BUILDING PERMIT

Job ID: 2010-12-176-OPB

Location/Address of Construction: <u>696 CONGRESS STREET</u>		
Total Square Footage of Proposed Structure/Area <u>1,814 sq ft</u>	Square Footage of Lot <u>0.78 ACRES</u>	Number of Stories <u>3</u>
Tax Assessor's Chart, Block & Lot Chart# <u>55</u> Block# <u>E</u> Lot# <u>32</u>	Applicant * <u>must be owner, Lessee or Buyer</u> * Name <u>MGO PROPERTIES LLC</u> Address <u>PMB 299 SO MARKET ST</u> City, State & Zip <u>S. PORTLAND 04106</u>	Telephone: <u>207-799-7502</u>
Lessee/DBA (If Applicable)	Owner (if different from Applicant) Name Address City, State & Zip	Cost Of Work: \$ <u>20,000⁰⁰</u> C of O Fee: \$ _____ Total Fee: \$ <u>220⁰⁰</u>
Current legal use (i.e. single family) <u>MIXED / OFFICE</u> Number of Residential Units <u>FOUR</u>		
If vacant, what was the previous use? _____		
Proposed Specific use: <u>SAME</u>		
Is property part of a subdivision? _____ If yes, please name _____		
Project description: <u>REPAIRS TO INTERIOR / EXTERIOR DUE TO VEHICLE COLLISION. EGRESS CHANGES PER PFD.</u>

designed by: JHL	696 CONGRESS STREET PORTLAND, MAINE FRONT ENTRY STAIR REPAIR AND NEW REAR ENTRY STAIR GENERAL NOTES	L & L STRUCTURAL ENGINEERING

696 CONGRESS ST.
PLOT PLAN

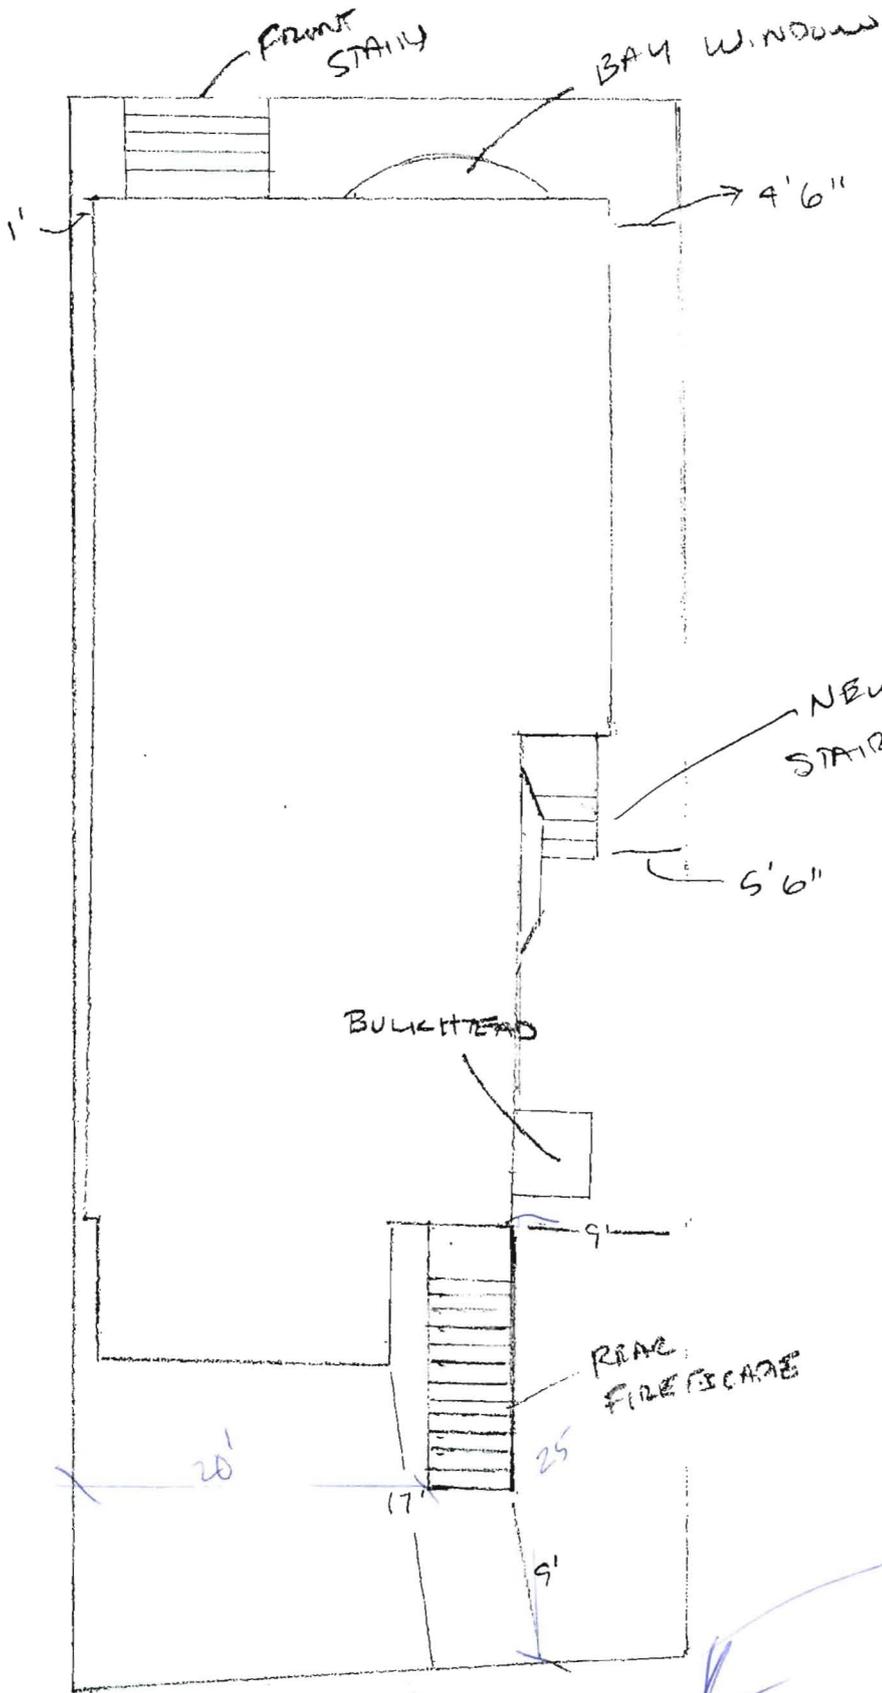
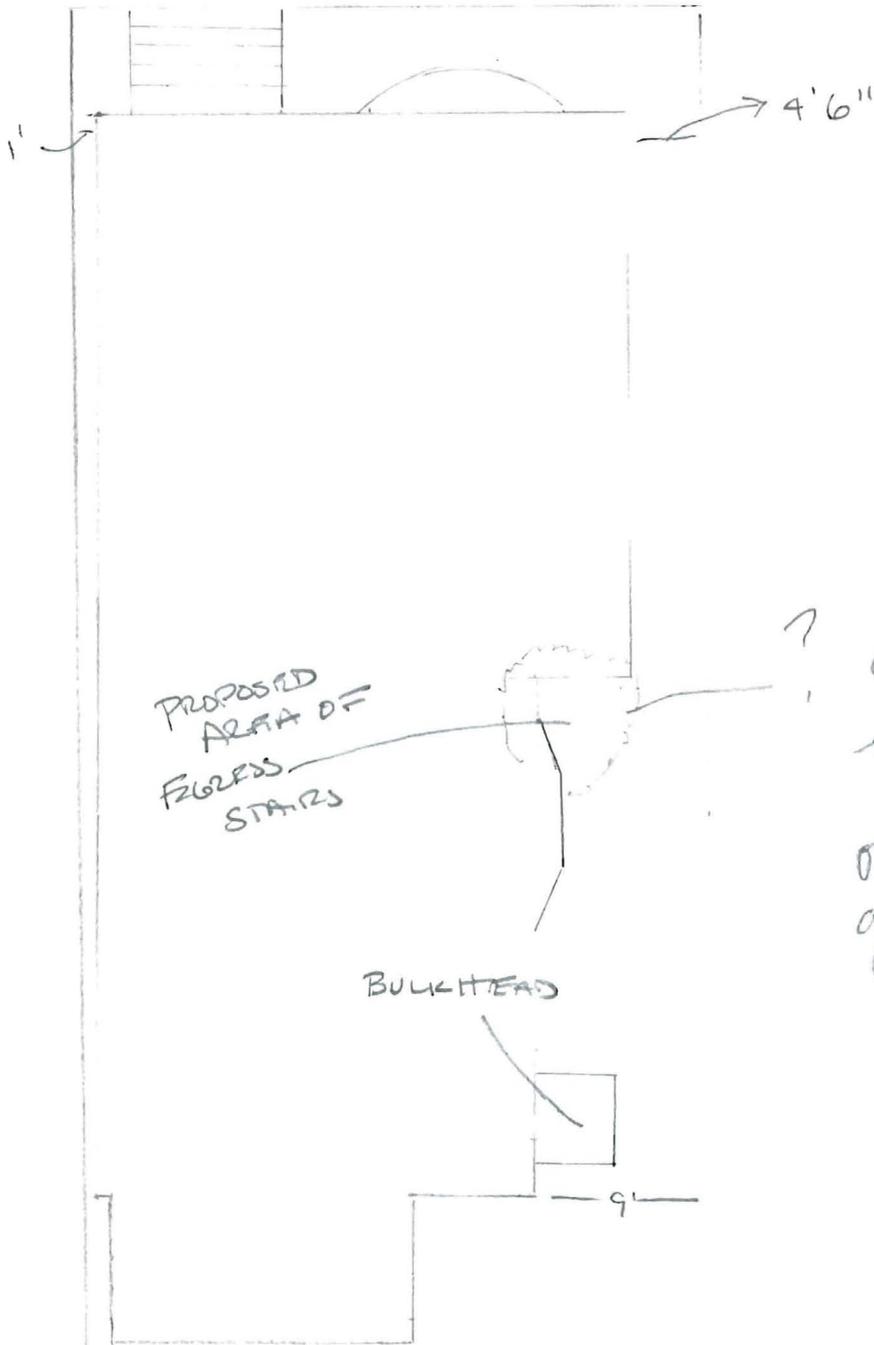
B2b egress doesn't need to be enclosed

NEW PLATFORM PER HISTORIC & PFD

5' side yd Reg ok
5'6" shown

90% in previous Reg
(3396[#] per Assessors)
339.6[#] min previous

$20 \times 17 = 340\#$
 $95 \times 9 = 225\#$

ok

CALL 12/30/10
 TALKED TO MARK —
 on Monday he will
 get me a revised plot
 plan showing dimensions
 to new →

REAR ENTRY STAIR-SECTION 1
 3/4" = 1'-0" S5

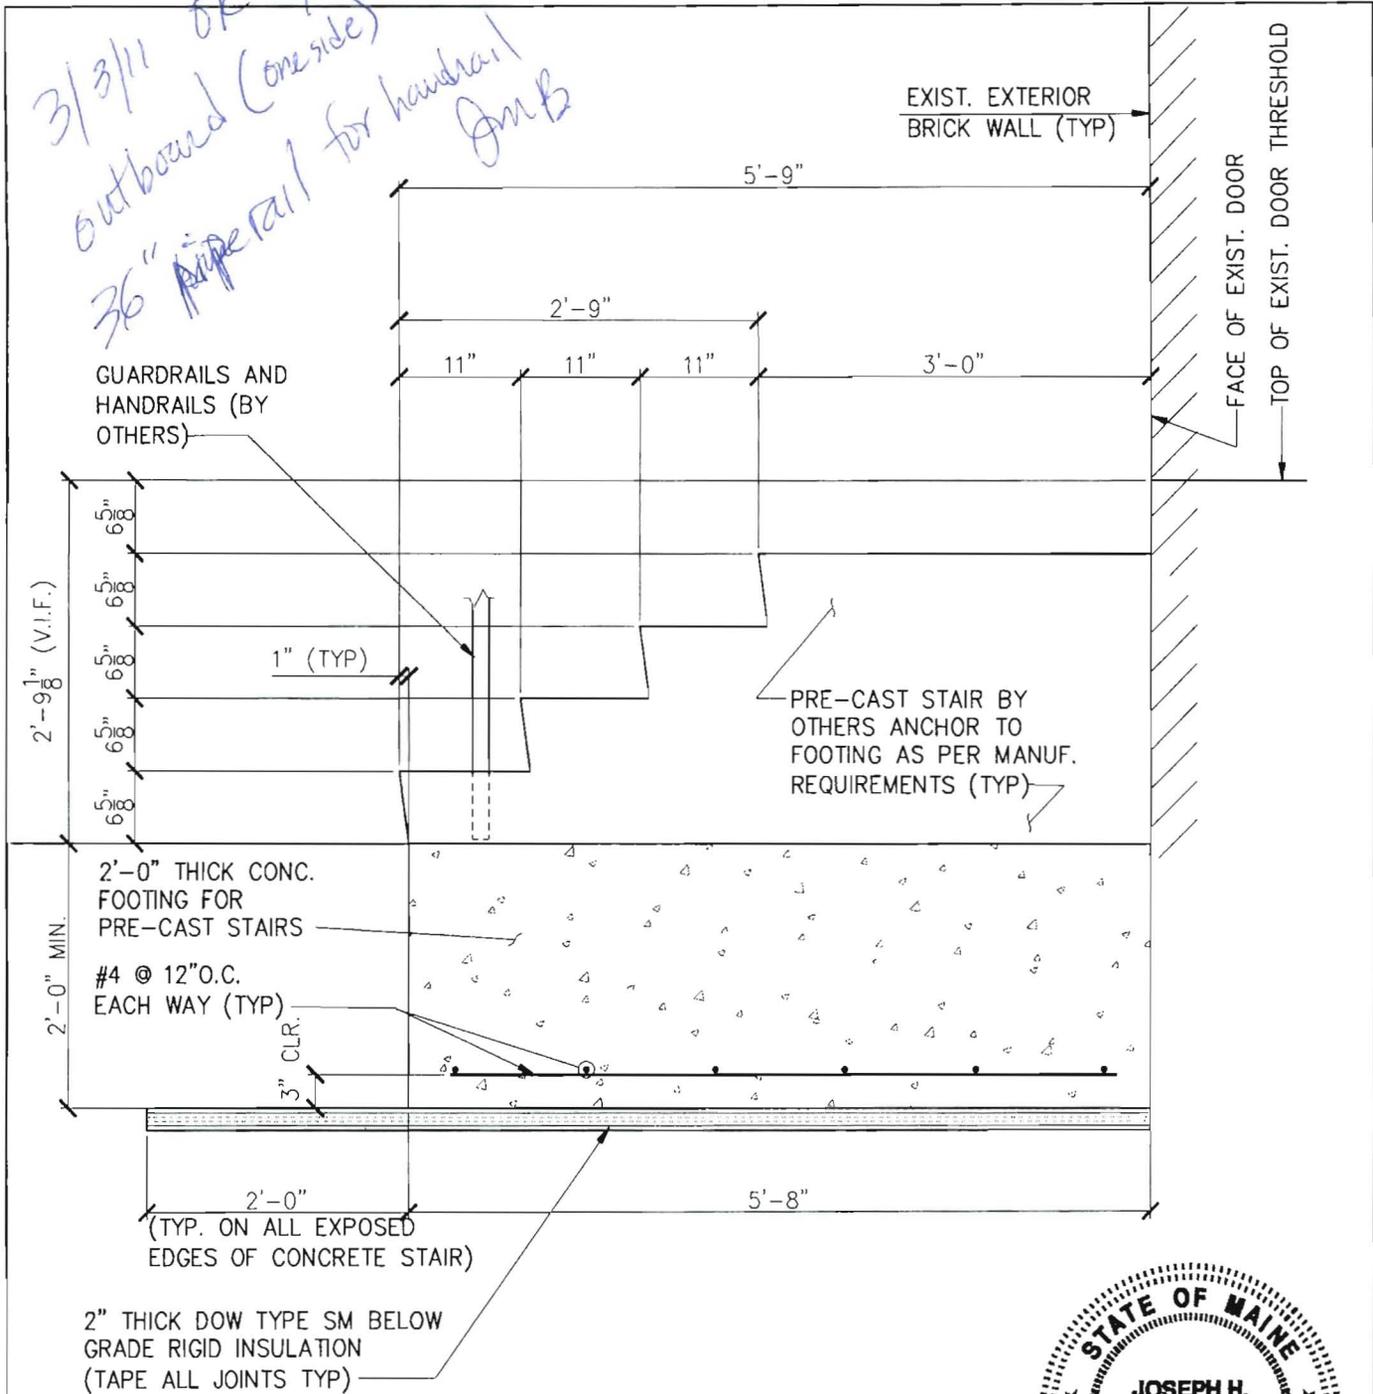
*3/3/11 OK w/ Deb A.
outboard (one side)
36" Pipe rail for handrail
Am B*
